NCC Public Comment Draft Response Sheet

This response sheet is to be used for submitting responses to the National Construction Code (NCC) 2022 Public Comment Draft.

Organisation: Housing Industry Association (HIA)

Wall Type vs. Wall Colour by Climate Zone

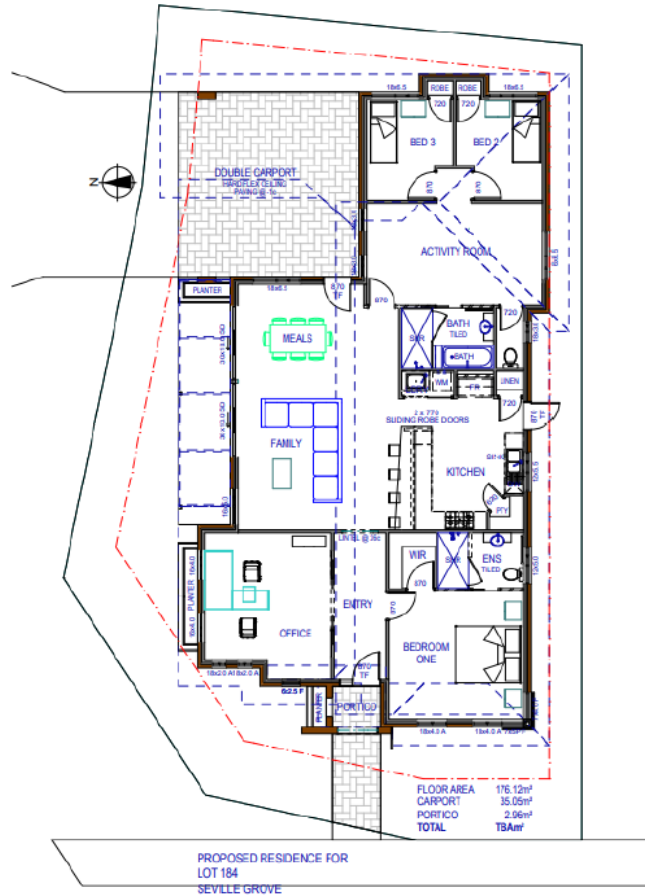
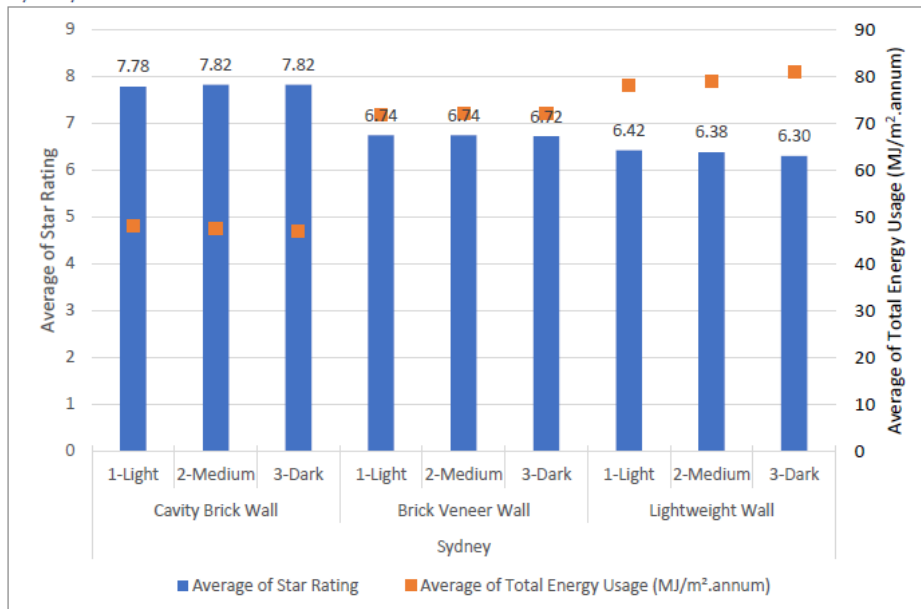
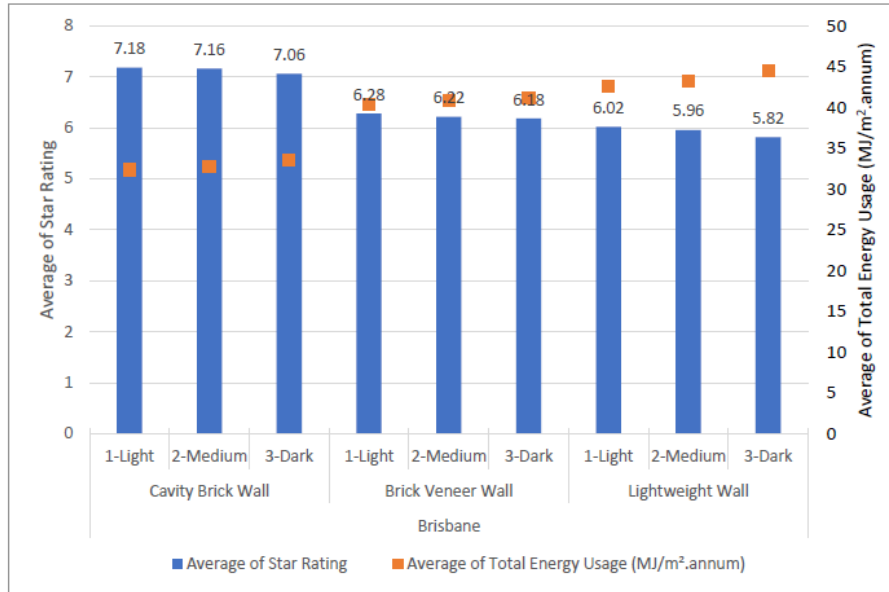
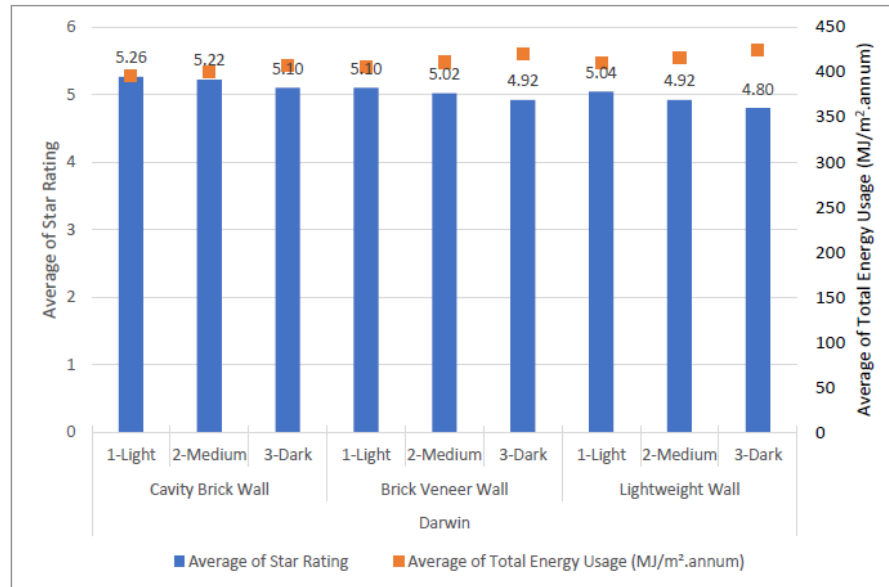
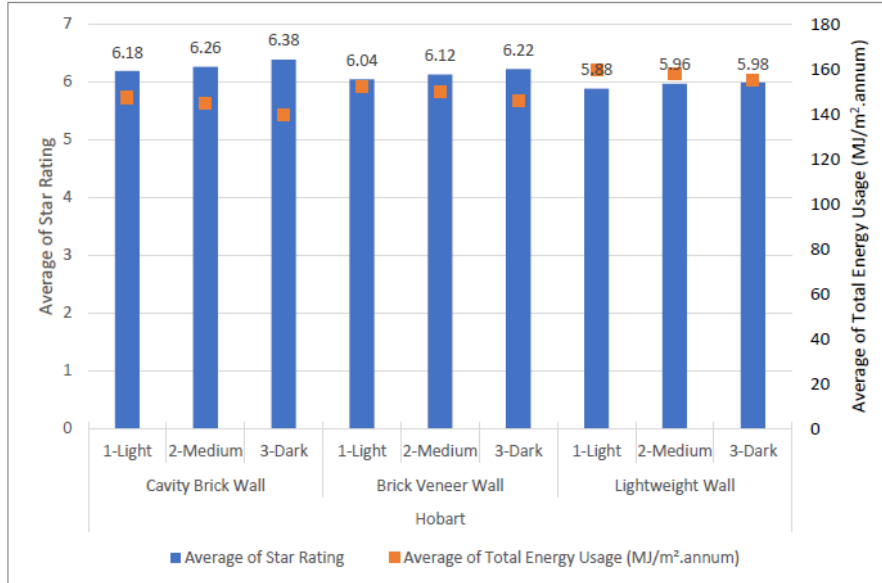
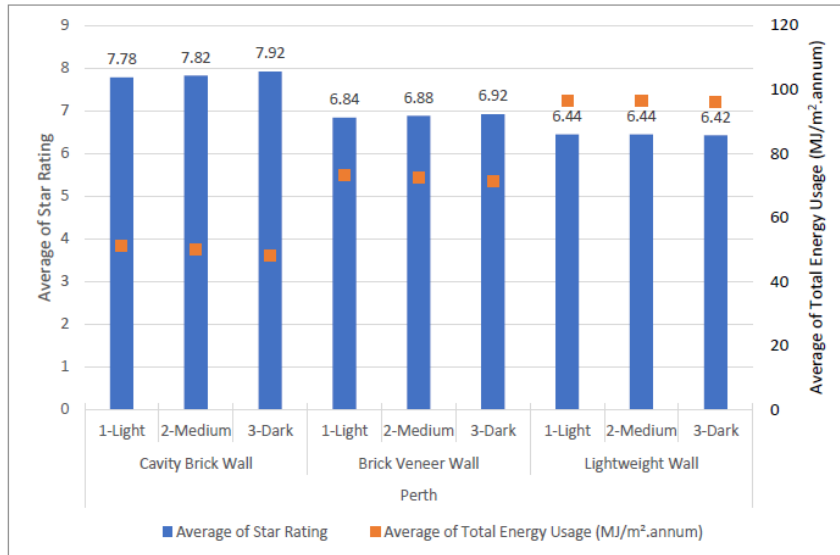
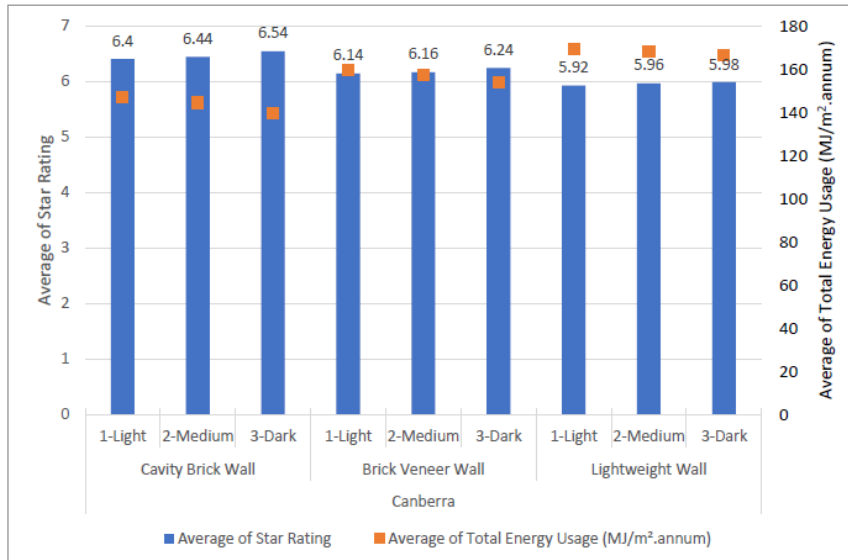
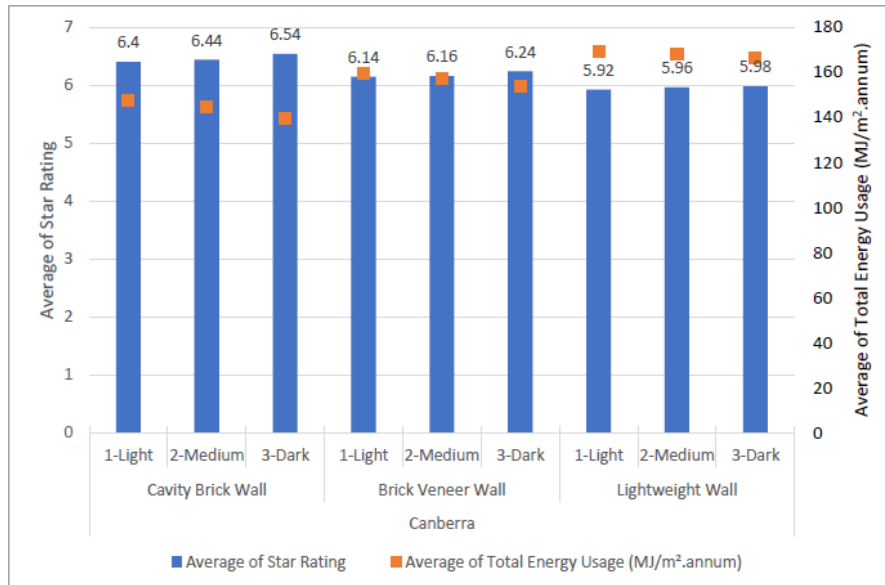
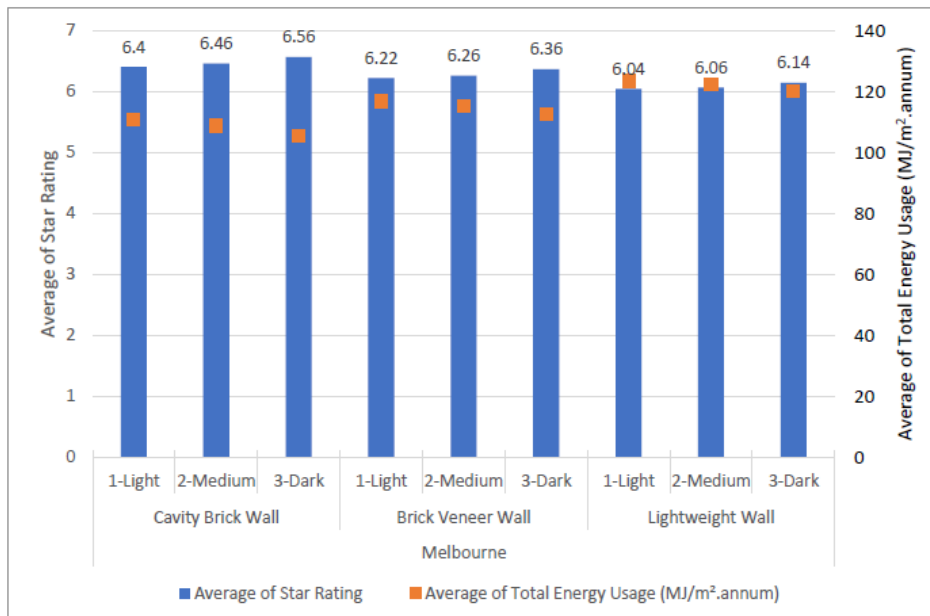
Remove provision restricting roof and wall colours in climate zone 1-5

This modelling contains the below graphs which compare the effect of wall construction type and wall colour across the 8 climate zones listed above. Roof colour was kept constant at medium and the insulation was averaged across all levels. The floor plan of the building that was modelled is below.

The modelling provided herein primarily relates to the roof colours but similar modelling was done for the walls which resulted in similar findings and can be provided to ABCB if required.

Figure 10.4 Wall thermal break construction

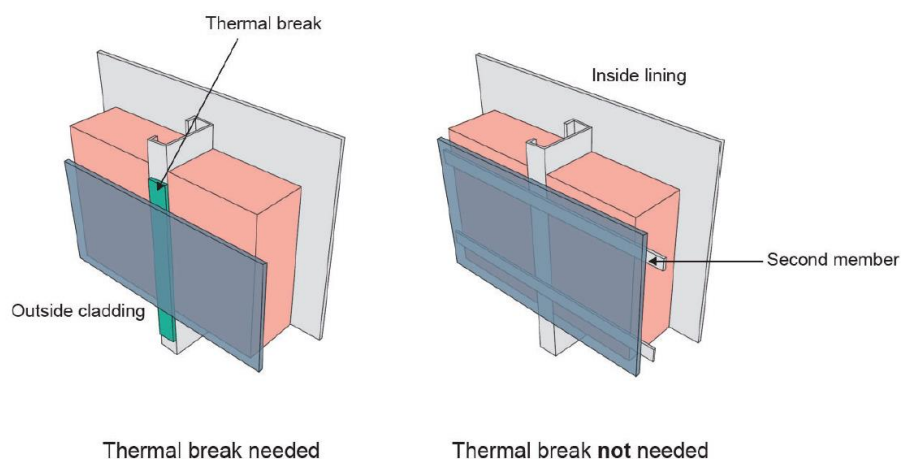
4. Batten construction – if a counter batten is used in a lightweight wall to create a space for insulation, will the batten require a thermal break and if so what value (if any) does this thermal break need to be?

Refer **Handbook: Energy Efficiency NCC Volume One Figure 10.4 Wall thermal break construction** – can this detail be included as a note or mandatory guidance within the Housing Provisions?
